**UN Regulation No. 22 (UN Regulation No. 22 (Protective helmets))**

### **Proposal for the 06 series of amendments of Regulation No. 22 (UN Regulation No. 22 (Protective helmets))**

**Submitted by the experts from the Informal Working Group on UN  
Regulation No. 22\***

The text reproduced below was prepared by the experts from the Informal Working Group on UN Regulation No. 22. The modifications to the current text of UN Regulation No. 22 are marked in bold for new characters and strikethrough for deleted characters.

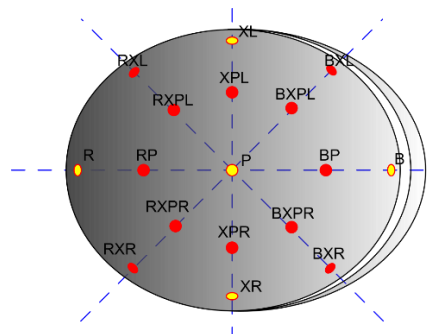
**The impact points shall be selected among the 12 points as listed below and depicted in figure.**

**BP - in the front-superior area, situated in the vertical longitudinal plane of symmetry of the helmet (0°) situated in the vertical plane and at an angle of 45° measured from Z above the AA' plane.**

**BXL - in the left (315°) front-lateral area, situated in the vertical plane and at an angle of 20° measured from Z above the AA' plane.**

**BXR - in the right (45°) front-lateral area, situated in the vertical plane and at an angle of 20° measured from Z above the AA' plane.**

**BXPL - in the left (315°) front-lateral-superior area, situated in the vertical plane and at an angle of 45° measured from Z above the AA' plane.**

**BXPR - in the right (45°) front-lateral-superior area, situated in the vertical plane and at an angle of 45° measured from Z above the AA' plane.**

**XPL - in the left (270°) lateral-superior area, situated in the central transverse vertical plane and at an angle of 45° measured from Z above the AA' plane.**

**XPR - in the right (90°) lateral-superior area, situated in the central transverse vertical plane and at an angle of 45° measured from Z above the AA' plane.**

**RXL - in the left (225°) rear-lateral area, situated in the vertical plane and at an angle of 20° measured from Z above the AA' plane.**

**RXR - in the right (135°) rear-lateral area, situated in the vertical plane and at an angle of 20° measured from Z above the AA' plane.**

**RXPL - in the left (225°) rear-lateral-superior area, situated in the vertical plane and at an angle of 45° measured from Z above the AA' plane.**

**RXPR - in the right (135°) rear-lateral-superior area, situated in the vertical plane and at an angle of 45° measured from Z above the AA' plane.**

**RP - in the rear-superior area, situated in the vertical longitudinal plane of symmetry of the helmet (180°) and at an angle of 45° measured from Z above the AA' plane.**

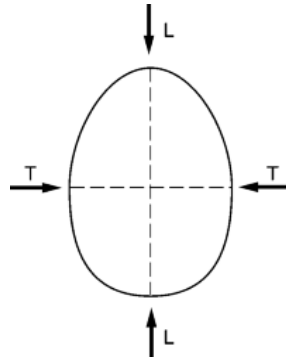
**7.4.3.2. A device to guide and release a falling mass (the total mass being 3 kg ± 0.1 kg) is hooked on to the front part of the chin section in the position "J" in the median vertical plane of the helmet (shown in annex 8, tested reversely)**

**7.4.3.3. The falling mass of 10 kg ± 0.01 kg is then released and drops in a guided free fall from a height of 0.50 m ± 0.01 m. The guiding devices shall be such as to ensure that the impact speed is not less than 95 per cent of the theoretical speed**

**7.4.3.4. the movement must be such to avoid any possible interference with 100 mm cylinder as defined in paragraph 6.4.2.**

**Peripheral vision – breath deflector**

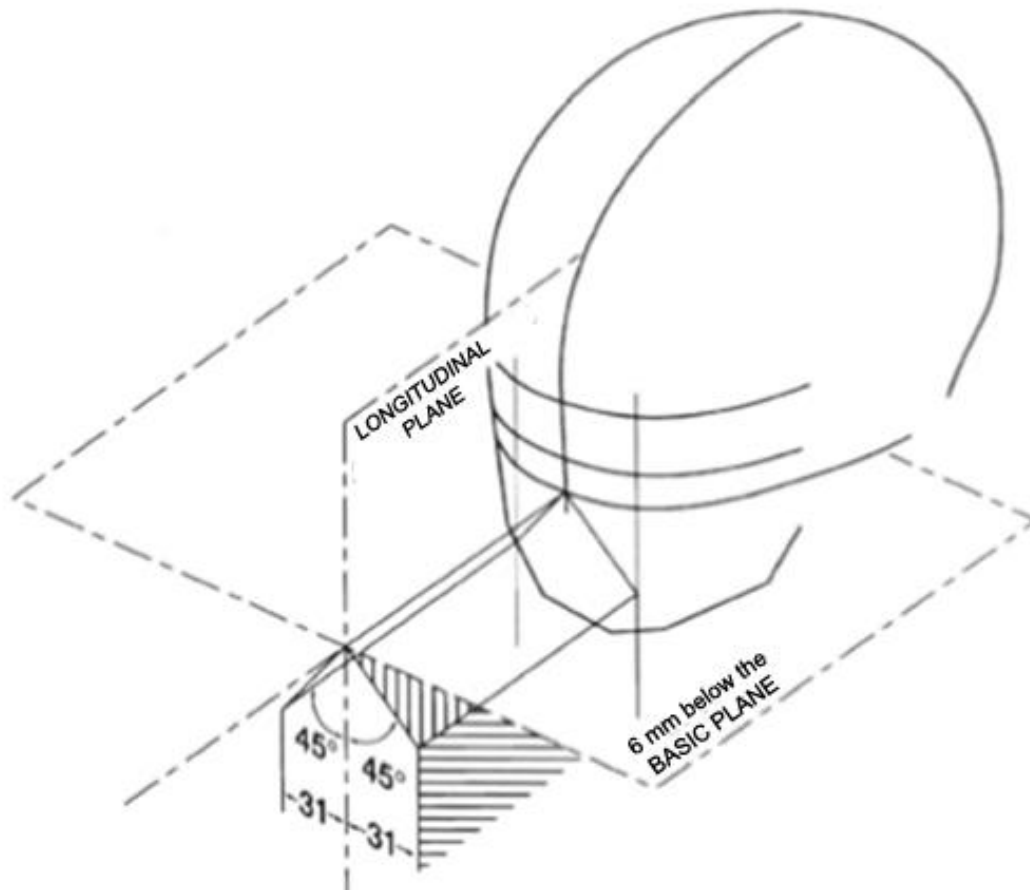
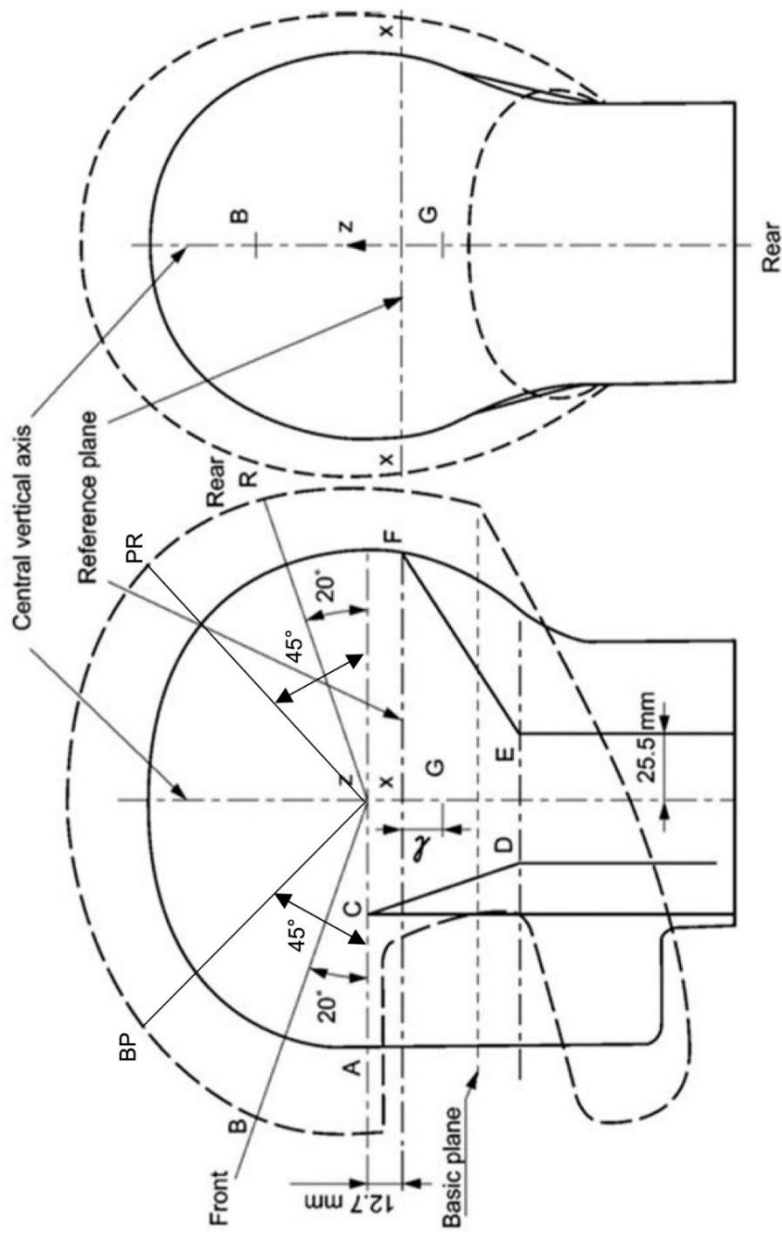
**The breath deflector allowance is shown in Annex 4 fig. 2D. It includes the region that is within 31 mm to the right and left of the longitudinal plane and that lies below the two planes that form 45° angles with the longitudinal plane and that intersect it at the level of the [6 mm] below the basic plane.**
